[Docket No. FAA-2020-0442; Project Identifier AD-2020-00260-E; Amendment 39-21640; AD 2021-14-13]

Airworthiness Directives; Pratt & Whitney Turbofan Engines

ACTION: Final rule.

Figure 1 to Paragraph (g)(1)(iii) – Crack Inspection Critical Areas

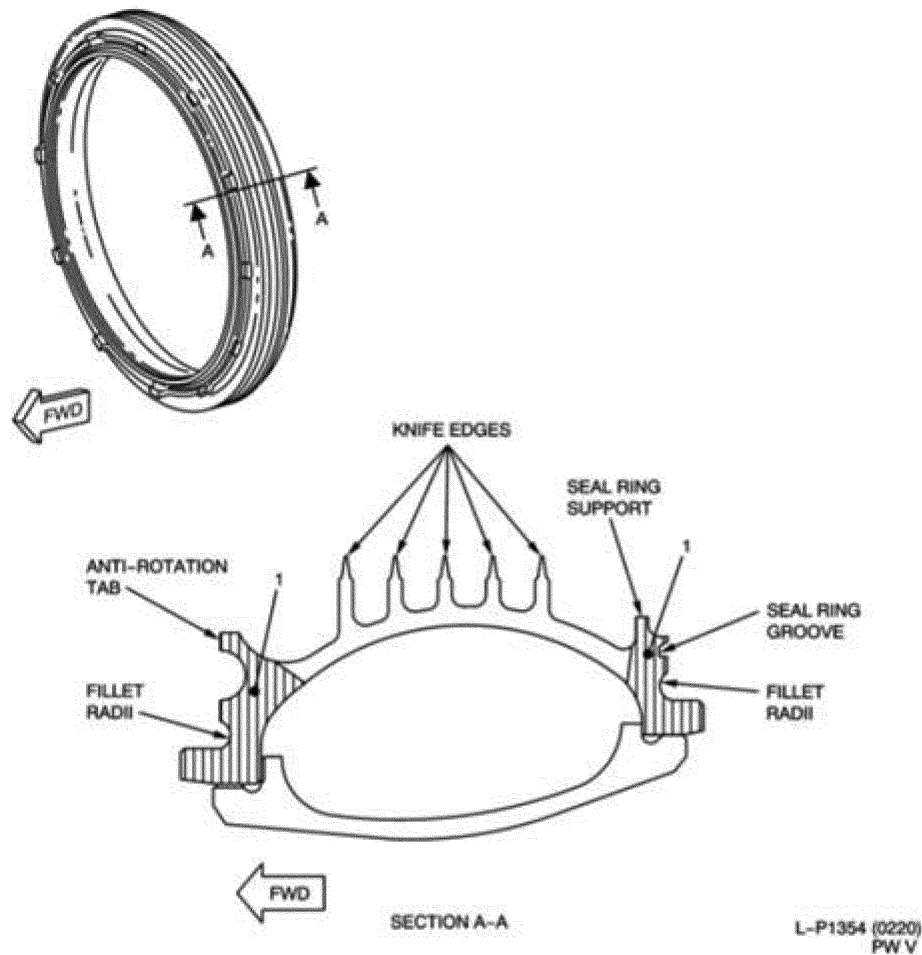
Delta commented that individual part serviceability should not depend on the inspection results of other parts. Delta also commented that if inspections are not possible which would allow the mating HPT 1st-stage disk or the HPT 2nd-stage hub to be deemed serviceable, independent from inspection status of the HPT 2nd-stage air seal assembly, then the manufacturer should revise the engine manuals to clarify that the mating HPT 1st-stage disk or HPT 2nd-stage hub cannot be made serviceable unless an inspection of the HPT 2nd-stage air seal assembly indicates it is free of cracks. Delta stated that this would remove the possibility that the mating HPT 1st-stage disk or HPT 2nd-stage hub would be made serviceable and then installed in an engine before the HPT 2nd-stage air seal assembly is inspected.

If a crack is found as identified in the shaded region of Figure 1 to paragraph (g)(1)(iii) of this AD (Figure 1) that

Delta and MTU requested that the FAA clarify the location of the forward and aft edges of the HPT 2nd-stage air seal assembly. Delta asked if the forward edge is the barrel section forward of the #1 knife-edge or any part that extends beyond the barrel section.

Delta and FedEx requested that the FAA clarify the definition of "through-crack." Delta asked if a "through-crack" is a crack going through the axial direction or radial direction of the HPT 2nd-stage air seal assembly. Delta referenced Figure 5 of NDIP-1217 that appears to show a through-crack in the axial direction. Delta inferred from paragraph (i)(4) of the NPRM that a through-crack is in the radial direction. Delta requested a diagram to help illustrate what constitutes a through-crack.

The FAA did not revise this AD in response to this comment. A crack, as identified in the shaded regions of Figure 1 to paragraph (g)(1)(iii) of this AD (Figure 1), which extends towards the knife-edge region of the HPT 2nd-stage air seal assembly, impacts the serviceability of the mating HPT 1st-stage disk and the HPT 2nd-stage hub. A crack identified in the shaded region of Figure 1 of this AD of the HPT 2nd-stage air seal assembly results in the

extends toward the knife-edge region of the HPT 2nd-stage air seal assembly, this AD requires replacement of the HPT 2nd-stage air seal assembly, mating HPT 1st-stage disk, and HPT 2nd-stage hub.

The FAA removed references to "forward edge" and "aft edge" of the HPT 2nd-stage air seal assembly from this AD. In their place, the FAA added Figure 1 to paragraph (g)(1)(iii) of this AD to specify the locations of the HPT 2nd-stage air seal assembly that require inspection for cracks.

The FAA agrees that it is difficult to differentiate between a surface crack and through-crack; therefore, the FAA removed references to “through-crack” from this AD. The FAA notes that any crack, in any direction, found in the HPT 2nd-stage air seal assembly, requires removal of the HPT 2nd-stage air seal assembly from service. As stated in an earlier response, the FAA added Figure 1 to show the locations of the HPT 2nd-stage air seal assembly that require inspection for cracks. However, the FAA is not providing dimensions that bind the areas. If the inspections of the HPT 2nd-stage air seal assembly reveal a crack in the shaded regions of Figure 1, which extends towards the knife-edge region, the HPT 2nd-stage air seal assembly must be removed from service.
